Nyack Union Free School District
District Wide Air Conditioning
- Cafeterias & Global Learning Commons
Nyack Middle School
Liberty Elementary School
Valley Cottage Elementary School
Upper Nyack Elementary School

The attention of bidders submitting proposals for the above referenced projects is called to the following Addendum to the Contract Forms and Specifications.

End of BID Addendum No. 2

1 PARTIAL SITE PLAN - UPPER NYACK
1/8" = 1'-0"

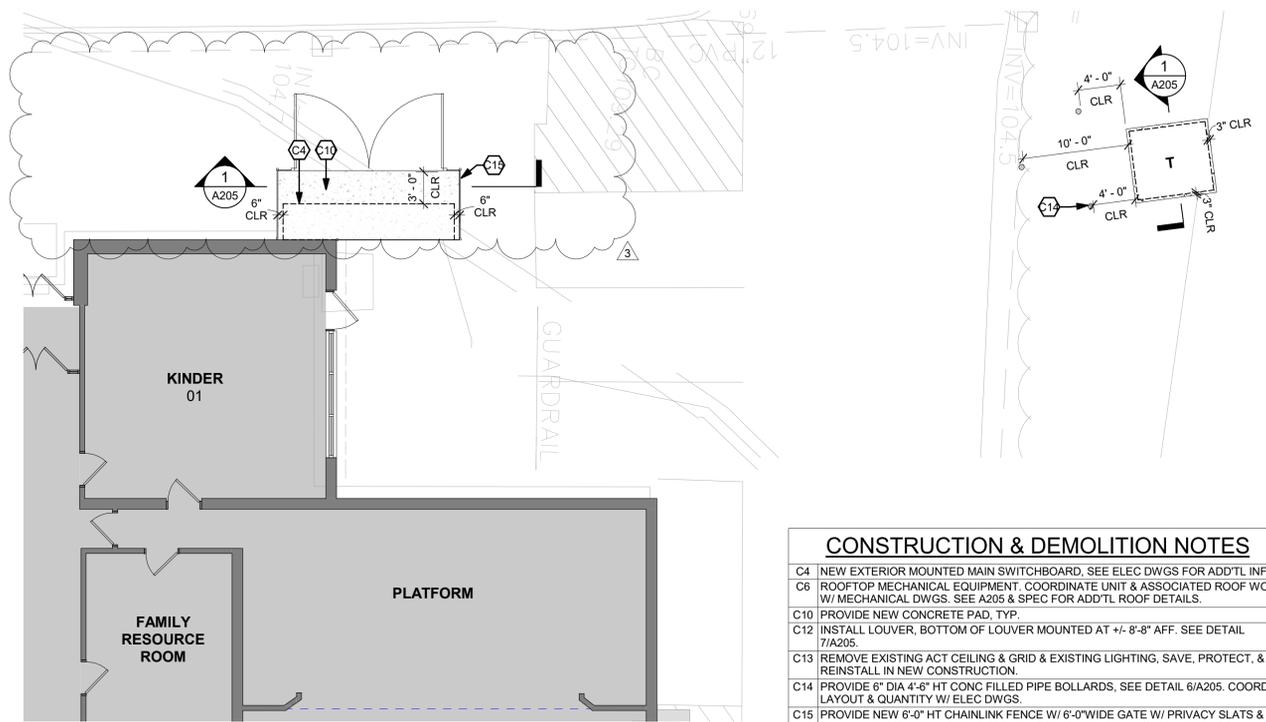
1. Refer to drawing A204 for revised location of concrete pad and fencing for main service switchgear.

UPPER NYACK ES
FIRST FLOOR
PLAN

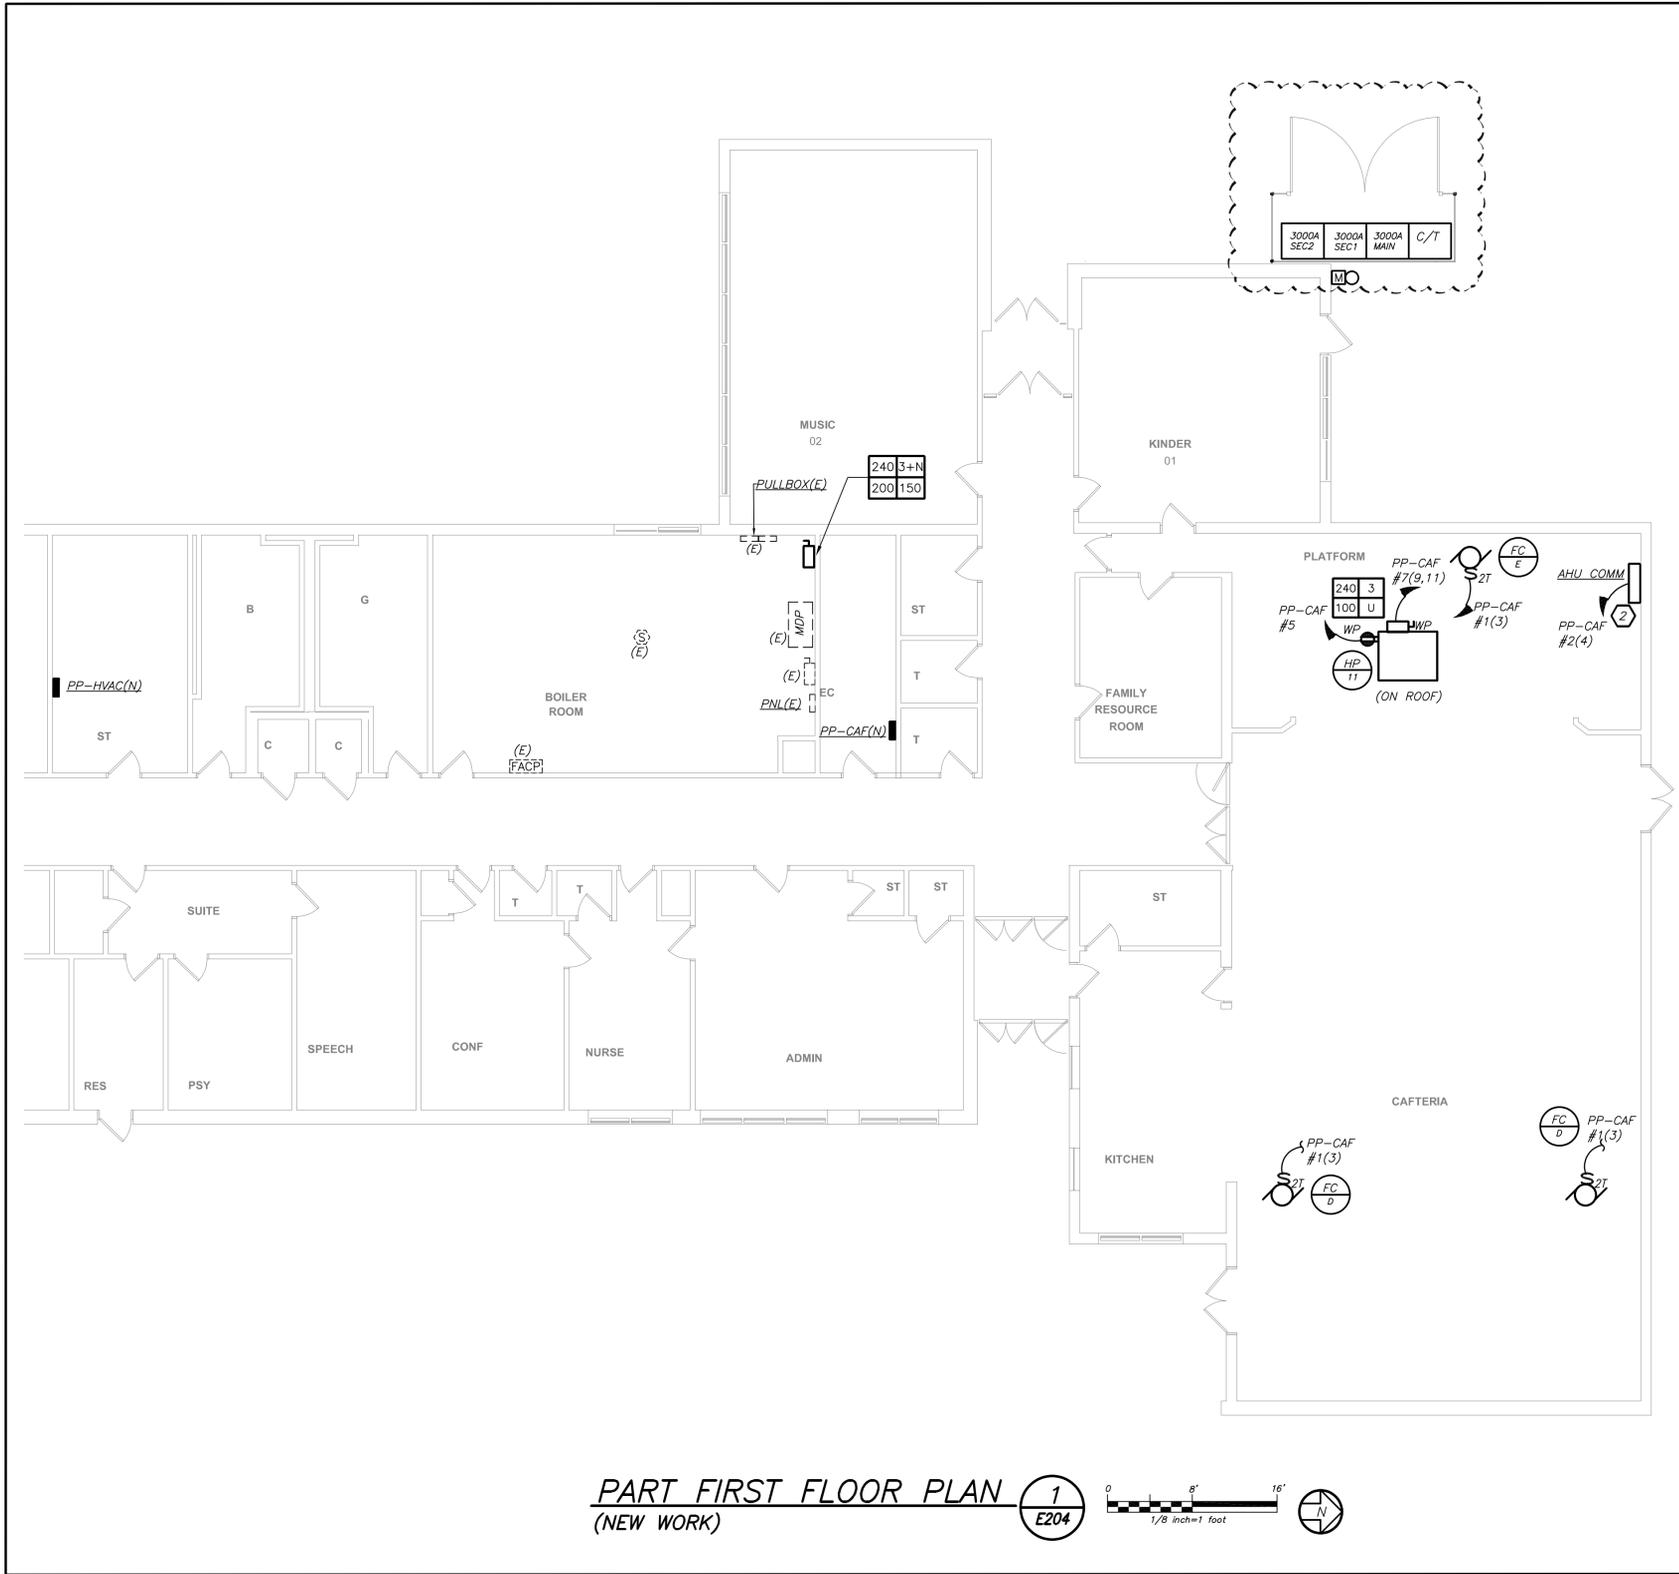
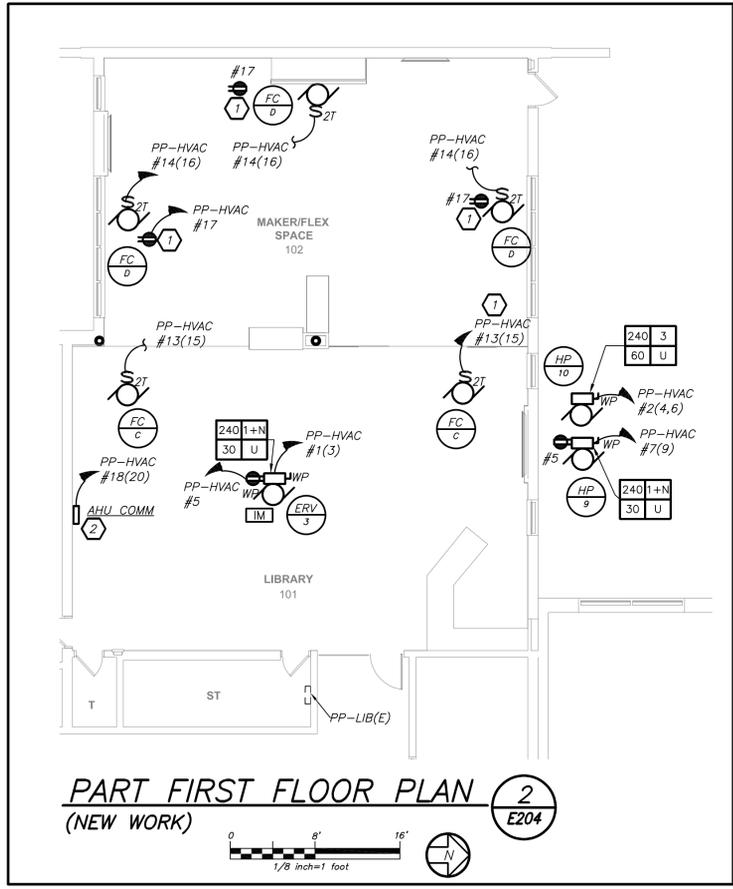
DRAWING E204 – UPPER NYACK ES FIRST FLOOR PLAN

1. Revised location of Main Service Switchgear.
